## **ADDITION TO TUCKER PLACE SUBDIVISION**

APPLICATION NUMBER 1 DATE May 5, 2016

REQUEST Subdivision

# DETAIL SITE PLAN

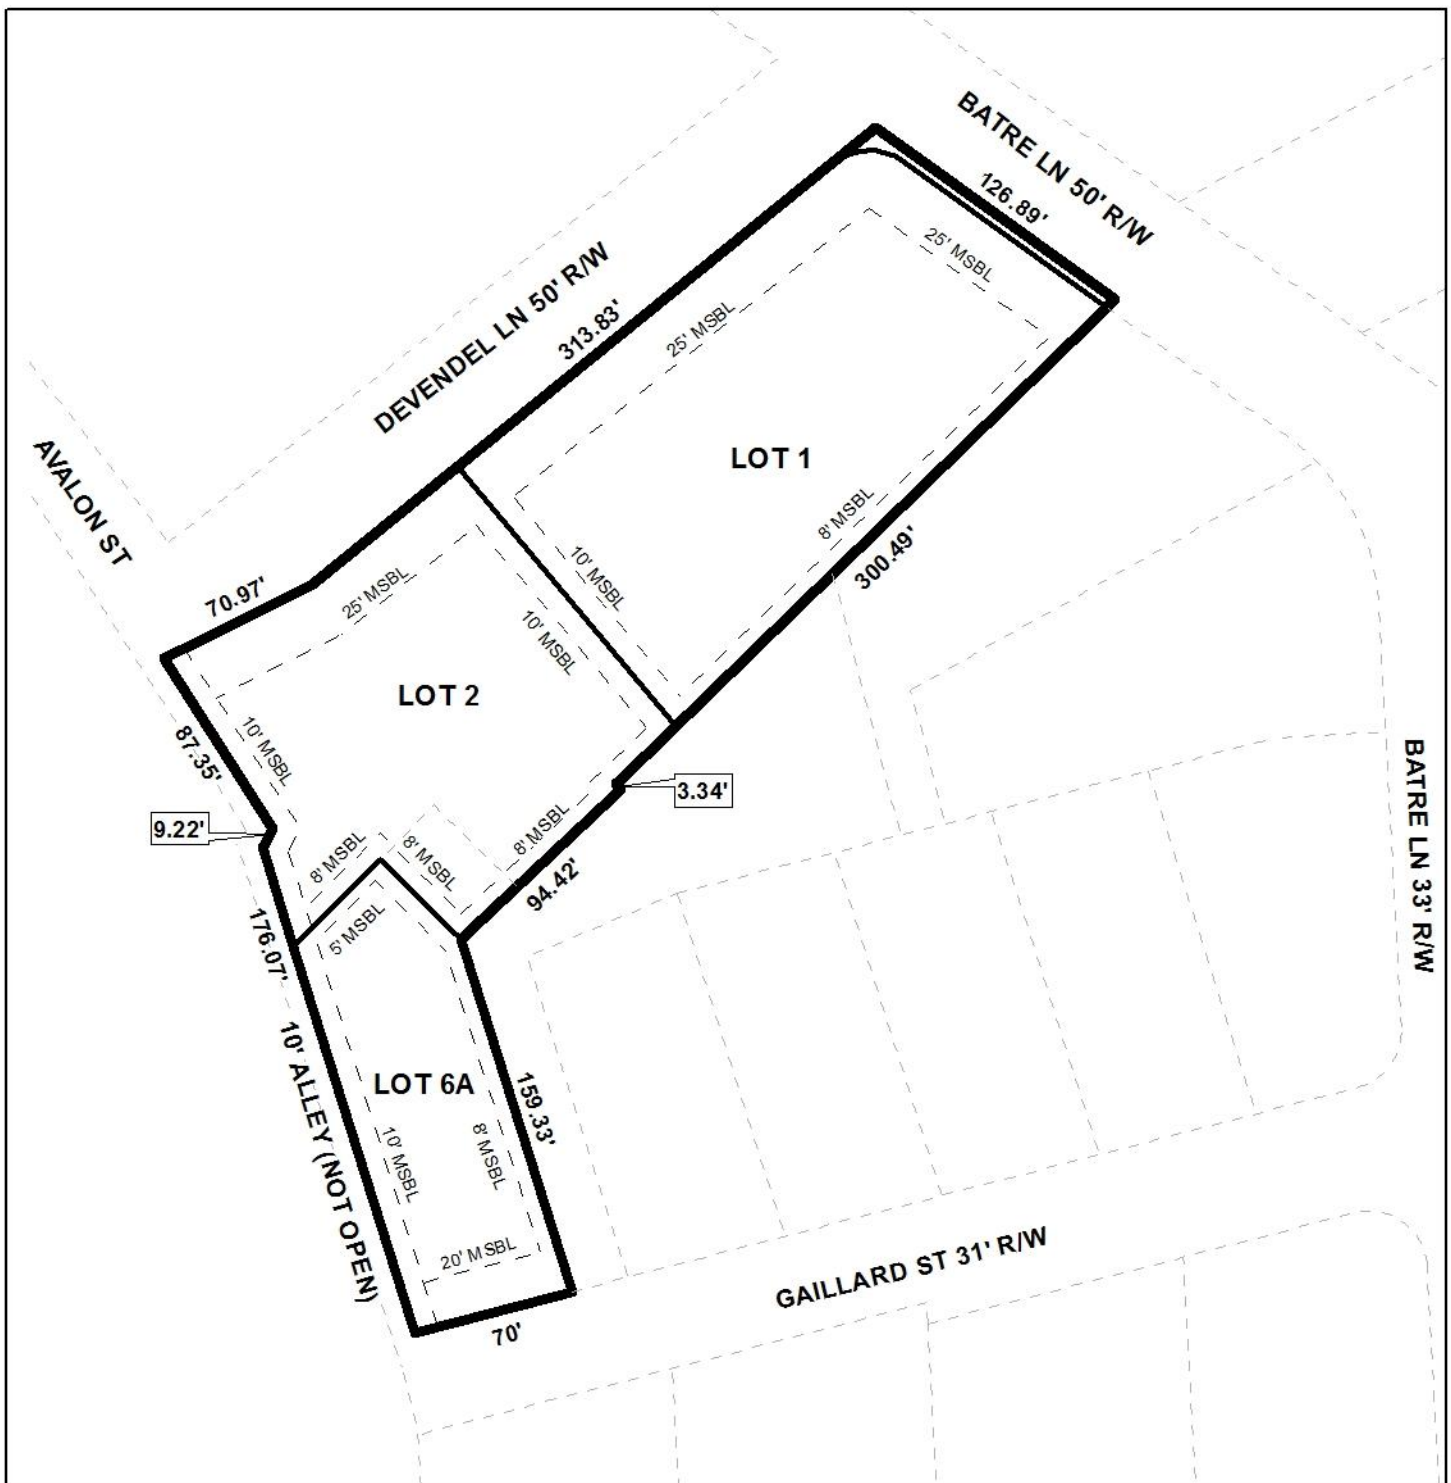
The proposed Lot 1 is a corner lot with frontage along Batre Lane, to the East, and Devendel Lane, to the West; proposed Lot 2 has frontage along Devendel Lane, to the North, and an unopened alley, to the West; and proposed Lot 6-A also has frontage along the unopened alley, to the West, and Gaillard Street, to the South. Batre Lane and Gaillard Street are minor streets without curb and gutter, each requiring a 60' right-of-way, and Devendel Lane is a minor street with curb and gutter requiring a 50' right-of-way. No dedication of the right-of-way will be required for Devendel Lane and Gaillard Street, however dedication on Batre Lane will be necessary: the plat appears to show dedication, but it is not labeled; the preliminary plat should be revised to illustrate a compliant 60' right-of-way width along Batre Lane, if approved.

It appears that dedication of a compliant 25' curb radius at the corner of Batre Lane and Devendel Lane is illustrated on the preliminary plat, and this information should be retained on the Final Plat, if approved.

As a means of access management, Lot 1 should be limited to two curb cuts to Devendel Lane and one curb cut to Batre Lane; Lot 2 should be limited to one curb cut to Devendel Lane; and, per previous subdivision approval of Lot 6-A, the lot should be limited to two curb cuts to Gaillard Street. Any changes in the sizes, designs, and locations of the aforementioned curb cuts are to be approved by Traffic Engineering and conform to AASHTO standards.

The proposed lots, as depicted, meet the minimum area requirements as regulated by the Subdivision Regulations, and are appropriately labeled in square feet and acres; this information should be retained on the Final Plat, or a table providing the same information should be furnished on the Final Plat, if approved.

The 25' minimum building setback line is shown on the preliminary plat for proposed Lots 1 and 2 and should also be retained on the Final Plat, if approved. It should be noted that proposed Lot 6-A, having been the subject of previous Subdivision and Planned Unit Development approvals, is illustrated with a reduced minimum building setback line and a combined side yard of less than 20 feet; to maintain such reduced setbacks and side yard widths will require new Planned Unit Development approval for the proposed subdivision, or revision of the plat to illustrate an appropriate 25' minimum building setback line and side yard setbacks will be required, prior to signing of the Final Plat.

- 1) *revision of the Final Plat to illustrate a compliant 60' right-of-way width along Batre Lane;*
- 2) *retention of the curb radii at the corner of Batre Lane and Devendel Lane;*

- 3) *placement of a note on the Final Plat stating that Lot 1 is limited to two curb cuts to Devendel Lane and one curb cut to Batre Lane, Lot 2 is limited to one curb cut to Devendel Lane, and Lot 6-A is limited to two curb cuts to Gaillard Street, with any changes in their sizes, locations, and designs to be approved by Traffic Engineering and conform to AASHTO standards;*

- 4) *retention of lot sizes in both square feet and acres on the Final Plat;*
- 5) *retention of the building setback line for each lot on the Final Plat;*
